Environmental Impact Statement – Supplementary Report

NOLANS PROJECT
ARAFURA RESOURCES LTD

OCTOBER 2017

Figure 3-9 Reaphook Channel (left) through to The Margins (high point) and the south-eastern extreme of the Ti-Tree Basin (right) (West to East)

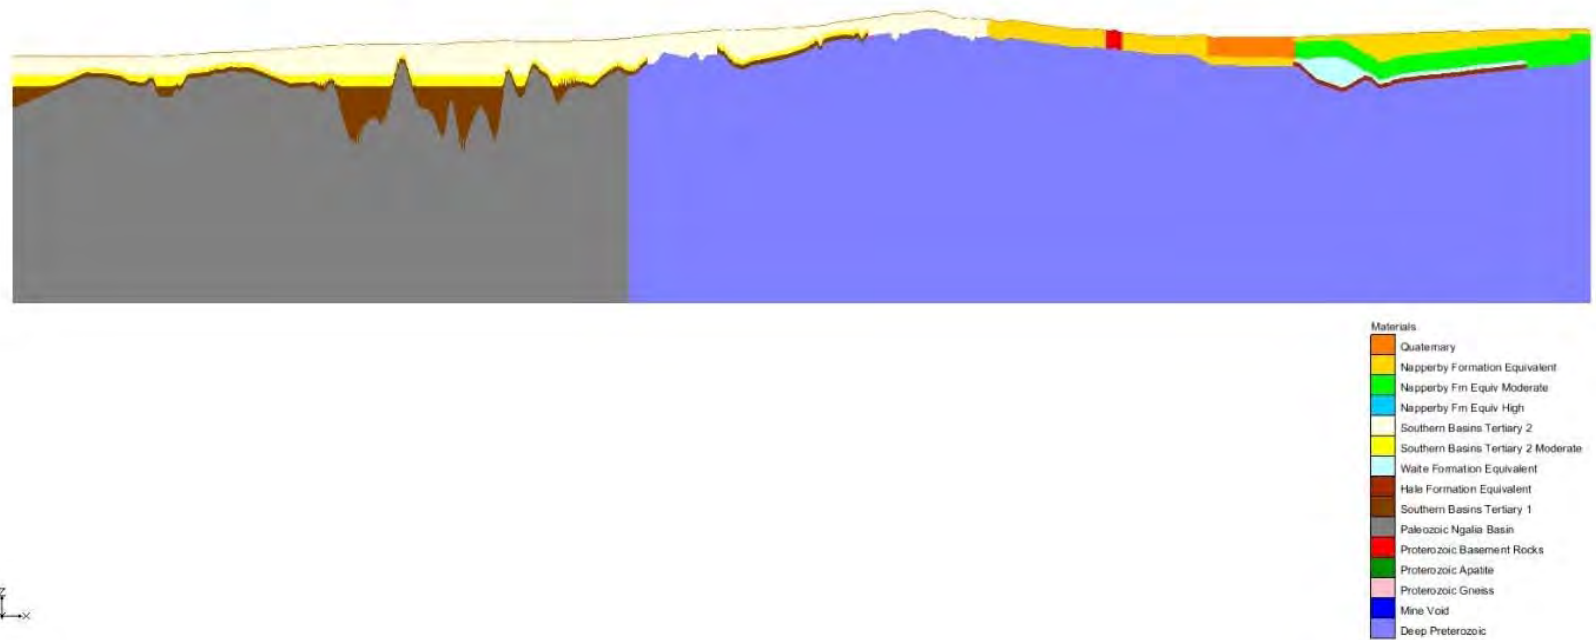
161	Provision of a cross-section through the hydrogeological model would assist in understanding its set up.	Due to the broad area and significant complexity in geometry, sections through the model vary significantly. Key sections that demonstrate the key model areas have been made and represented in the digital appendix (Appendix 8). An extract from the digital appendix is presented below (Figure 3-9 and Figure 3-10). The digital appendix contains a visualisation of the model geometry and conceptual hydrogeology (Appendix 8).

Restricted speed areas
near threatened species habitat **Figure 3-12**

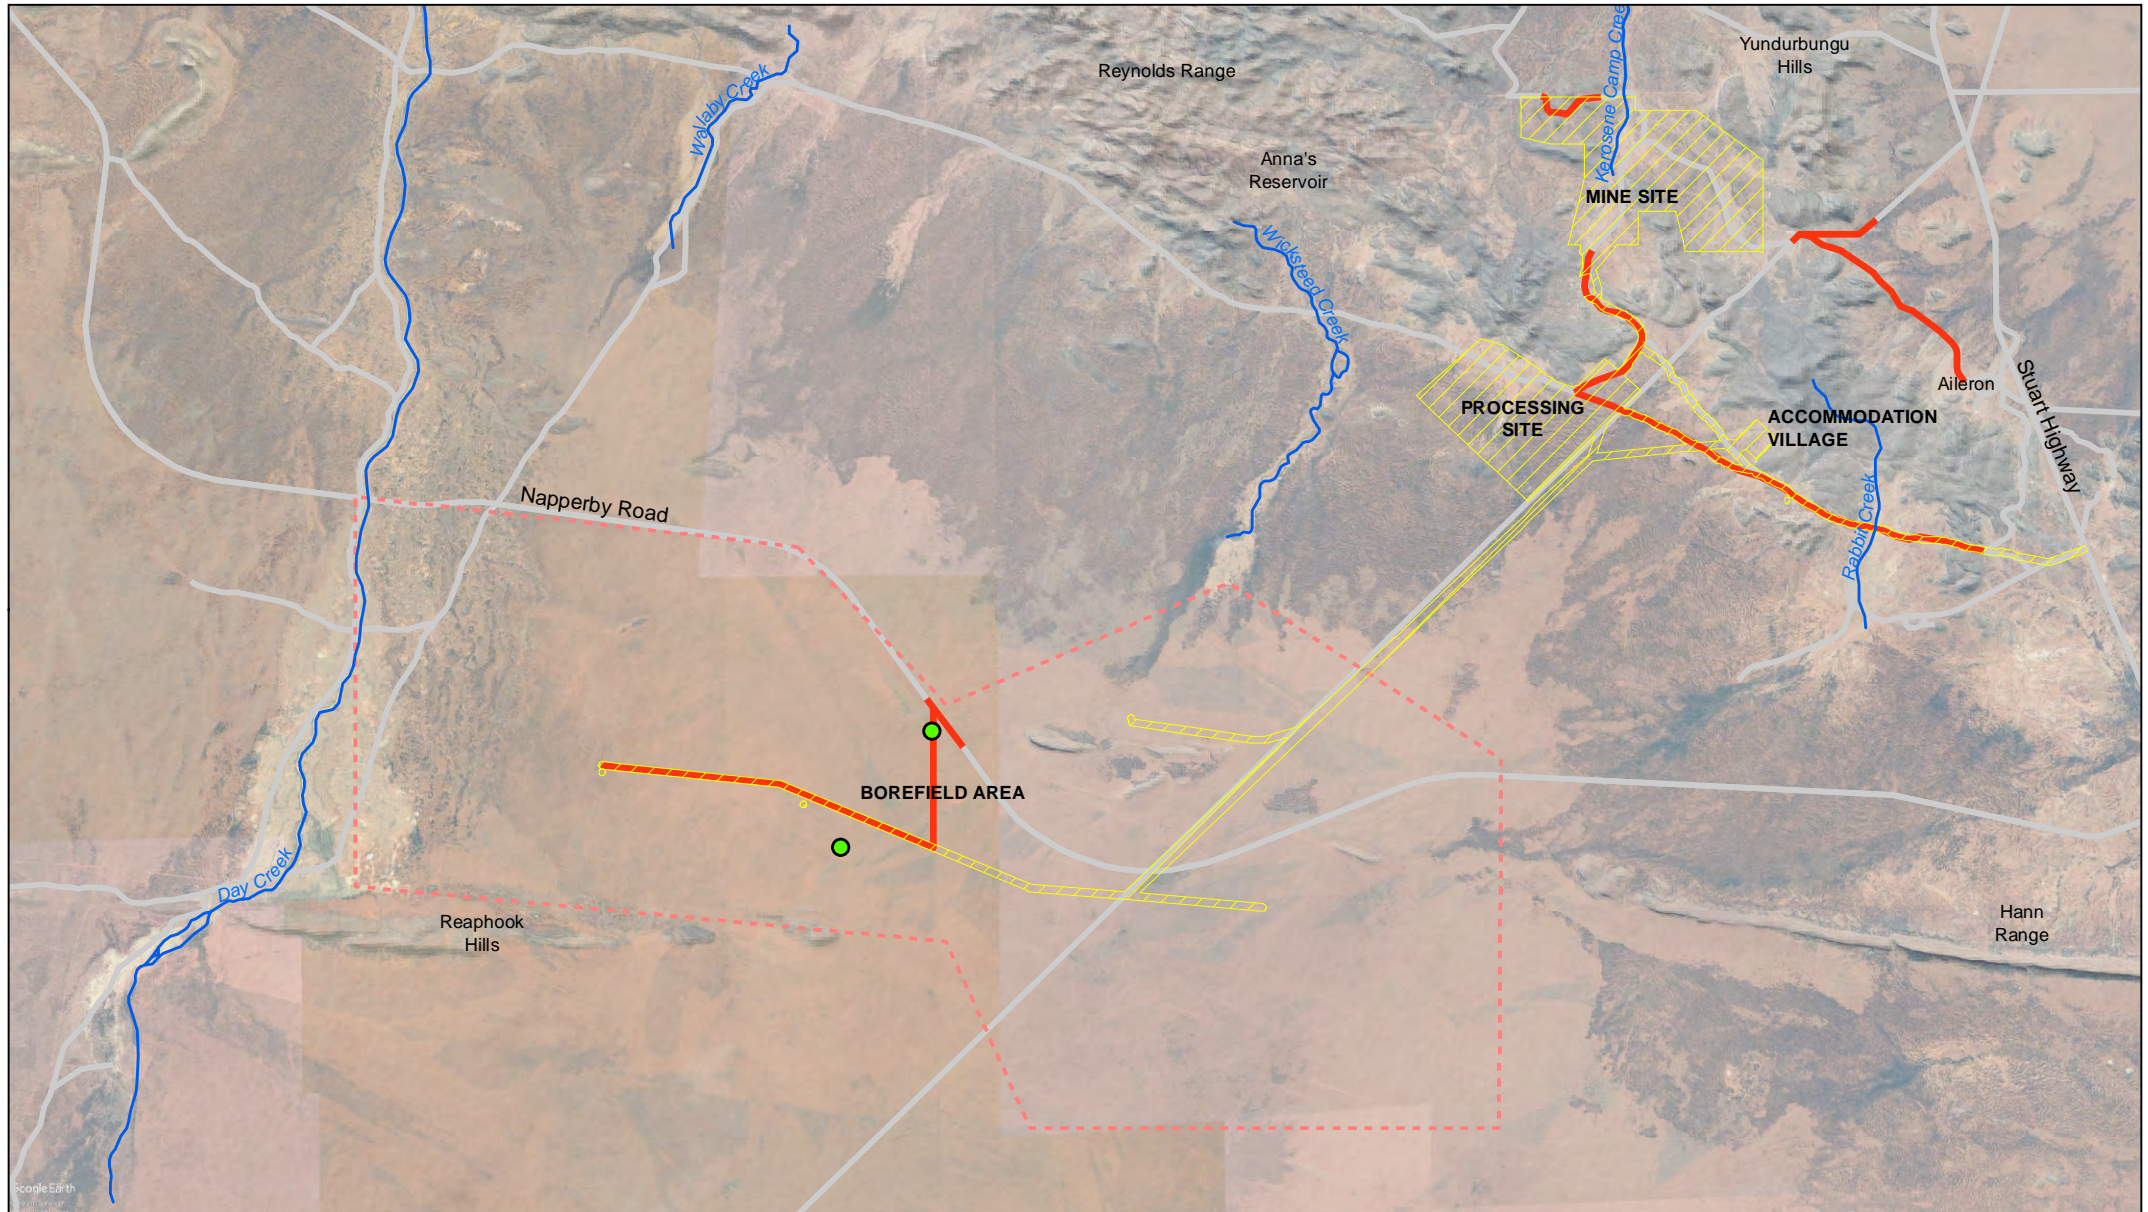
UID	Summary of submission	Response
488	<p>(a) Figure 9-1 indicates that the flora / vegetation survey did not cover the area of groundwater drawdown from the bore field (or other potential off-site / off lease impacts), targeting areas of potential direct physical disturbance of vegetation (e.g. clearing). In order to assess potential impacts of groundwater drawdown on any groundwater dependent and/or threatened vegetation, baseline vegetation data and assessment of potential impacts needs to be presented for all areas that may be affected by this activity.</p> <p>(b) It is stated in Section 10.7.10 that “The Nolans Project TSF/RSFs will be quite small (approx. 244.03 ha) and will likely contain free- standing supernatant water”. Any water source in a dry landscape could potentially be utilised by birds as a primary watering point, particularly once the birds become accustomed to visiting the site. Mitigation measures to address</p>	<p><u>Part A</u></p> <p>Mapping and ground-truthing of vegetation along Day Creek and the associated floodplain was completed by Desert Wildlife Services after the lodgement of the EIS, and is provided in Appendix 9.</p> <p><u>Part B</u></p> <p>Refer to Section 4.19.</p> <p><u>Part C</u></p> <p>Ore mining will occur during daylight hours while waste mining will occur 24 hours a day. This activity will require vehicle movements within and between the mine site and processing site. Activities within the borefield will only occur during daylight hours except for emergency maintenance.</p> <p>The speed limit on the bitumen access road will be 100 km/h and on gravel roads will be 80 km/h. The speed limit will be reduced to 60 km/h when the road passes in close proximity to sensitive areas and on all gravel roads between dusk and dawn. Sensitive areas will be defined as roads passing in close proximity to threatened species habitats, including within</p>

UID	Summary of submission	Response
	<p>potential impacts on fauna from waste water need to be provided (i.e. not “Looking into, where necessary..”)</p> <p>(c) It is stated in Section 10.7.12 that “Implementation of speed limits and possibly the reduction in vehicle travel at night” would be a mitigation measure to address potential impacts on fauna from vehicle strike. This needs to be addressed in more detail, as use of the word ‘possibly’ does not provide any assurance.</p>	<p>approx. 1 km of the known Great Desert Skink warren in the area supporting ‘older’ spinifex that possibly could be from 5-10 years post fire. Figure 3-12 below indicates specific areas where a 60 km/h speed zone will be imposed in close proximity (e.g. within 200 m of rocky habitat) to Black-footed Rock-wallaby and Great Desert Skink habitats.</p> <p>Signage that highlights the possible presence of wildlife will be installed where appropriate across the site.</p> <p>The implementation of speed limit strategy has been included as a commitment.</p>

Figure 3-13 Radiation monitoring points (Appendix P of EIS)

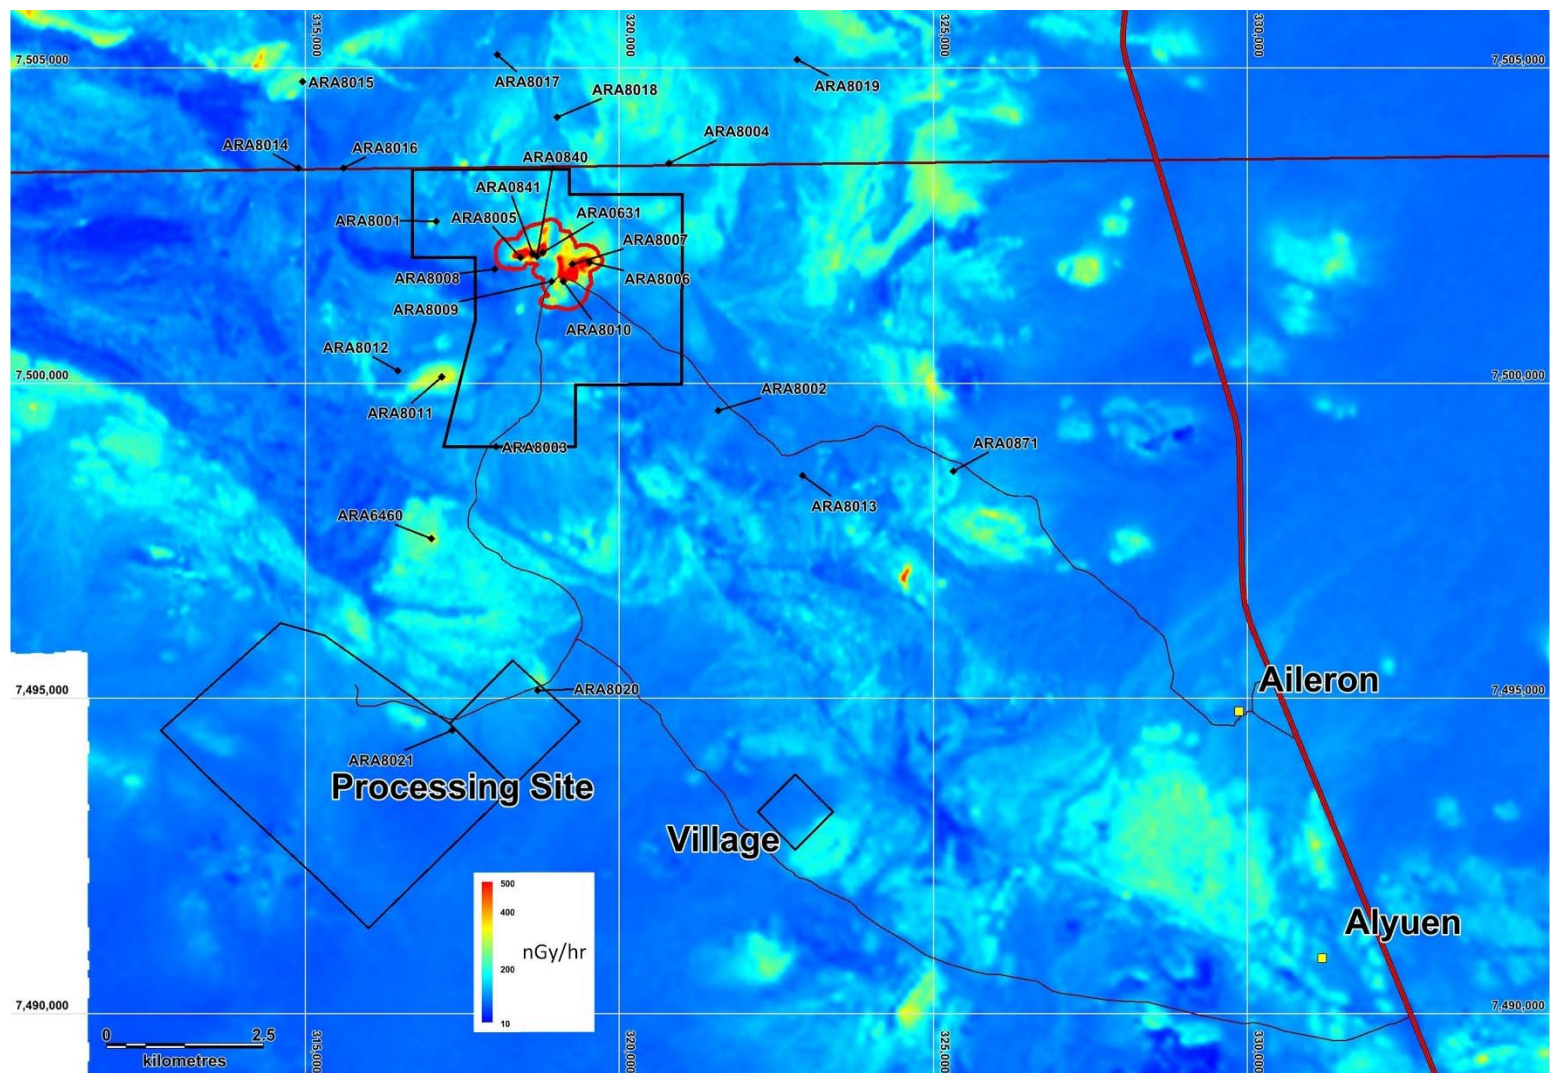
492	<p>‘A general area survey was conducted in a grid pattern across the mine site area and at sites remote from the project area. The remote sites are referred to as “background sites” and include two measurements in Kerosene Camp Creek and two measurements at the Aileron Roadhouse.’</p> <p>Kerosene camp Ck sites (incl. ARA08011) are mentioned as being used as ‘background’ sites.</p> <p>Sites ARA8014-016 and ARA8011 are shown in Aerial</p>	<p>The monitoring locations, detailed in Figure 3-8, show that the sites are widespread and representative of the area. Furthermore it should be noted that it would be remiss to omit a few higher spots as isolated higher spots up to 1000m² or more occur in the region. This was explained in the regional geology and background section of Hussey in Appendix P of the EIS. These isolated spots are not mineralisation. They are natural concentrations in rocks and soils.</p> <p>The figure shows the location of the environmental monitoring sites based on a calibrated high-resolution detailed low-level airborne radiometric image. This image shows the natural variations in radioactivity and the environmental dose rate across the project area. The image is a linear stretch of the data with all values of 500nGy/hr or more all shown as red. Hence</p>

UID	Summary of submission	Response
	<p>gamma surveys (Figure 12-2) to be localised gamma radiation hotspots (another deposit?). Their use may therefore skew calculation of local 'background' radiation conditions, particularly if they represent a large proportion of the data points used to calculate a 'background' value (Table 12-1).</p> <p>Provide justification for selected locations and groupings of monitoring points underlying calculations of radiation levels onsite.</p>	<p>this image emphasises the variation in the lower values. The cooler colours on this image have lower natural background radioactivity. The warmer colours have higher natural background radioactivity. The images clearly shows that the selected sites are representative of the area.</p> <p>Arafura completed several detailed grid-based surveys over the deposits area to determine the natural environmental radioactivity in the deposit area. These and the environmental monitoring sites were used to confirm the calibration of the airborne survey, see Hussey in Appendix P of EIS.</p> <p>All environmental monitoring sites were originally selected based on Arafura's knowledge of the region and geoscientific data. However, the actual spots were sited once ground-truthing was completed by Arafura's Senior Field Supervisor at each location. The selection was primarily based on the vegetation and soil cover at or near each site. Some places were up to 100m from the proposed target spot. The instructions provided to field staff was to find a point near this target spot that was easy to access and had sufficient soil and vegetation (grass/trees) for paired sampling. This was considered a very important factor in the site selection we believe the assessment of radioactive uptake is also an important factor to understand. Hence the actual monitoring spot was not biased in its selection based on measuring background radioactivity at each site. This measurement was taken after the fact.</p> <p>Environmental monitoring sites within the pit were based on Arafura's geological knowledge however the location of vegetation governed the actual site selection. These sites are considered typical of the deposit. They are not the areas of known highest radioactivity within the deposit footprint.</p> <p>The sites outside of the pit were selected as follows.</p> <ul style="list-style-type: none"> • ARA8001-ARA8004 inclusive are long-term dust monitoring sites outside of the deposit footprint area. These are upwind, downwind and orthogonal to the prevailing wind direction. It made sense to add these to the list of environmental radiation monitoring sites to enable long term collection of data. • ARA8008 was selected as a low radioactivity area just outside of the pit. This site may be too close to the LOM pit but it will serve as a useful monitoring site for many years to come. <p>The other sites were targeted by considering the location of the pit and infrastructure together with the prevailing wind direction and distance from the ML or pit.</p>

UID	Summary of submission	Response
		<ul style="list-style-type: none"> • A group of sites were selected at about 1km from the ML. These are ARA8012, ARA8016, and ARA8018 to the W, NW and N. Another group of sites were selected at about 5km from the centre of the pit. These are ARA8014, ARA8015, ARA8017. These have variable but mostly low environmental radiation levels. Some of these are likely to form key additional downwind monitoring sites. • ARA8013 and ARA8019 were selected as distal background sites. ARA8013 is significantly upwind while ARA8019 is orthogonal and significant distance from Nolans. ARA0871 has been used as a standard background biogeochemical (vegetation) sampling site for almost 10 years. It made sense to include this site as well as the most distal upwind site. • ARA8011 was specifically targeted as example of an average outcrop of felsic granitic gneiss from this area. The radioactivity is slightly higher than its surrounds but it is similar to many other felsic gneiss outcrops in the region. Site ARA8012 would have similar radioactivity to ARA8011 if the soil was removed. This is also similar to some of the gneiss that hosts the deposit. • ARA6460 was specifically targeted by me based on geological reconnaissance mapping of radiometric exploration targets. This general location is another felsic granitic gneiss outcrop with naturally elevated radioactivity although it contains an elongate pod of biotite schist with near this spot. The monitoring site is located within an area of high natural background radioactivity and is similar to that observed at Nolans Bore. ARA6460 is not sited on the highest radioactivity. A larger area of higher background activity occurs about 7.5 km E of ARA6460. This site is also similar to Nolans Bore but it has not been targeted. <p>Two sites were targeted within the processing site. The dose rate image clearly shows that the village site has similar of lower background radioactivity.</p>
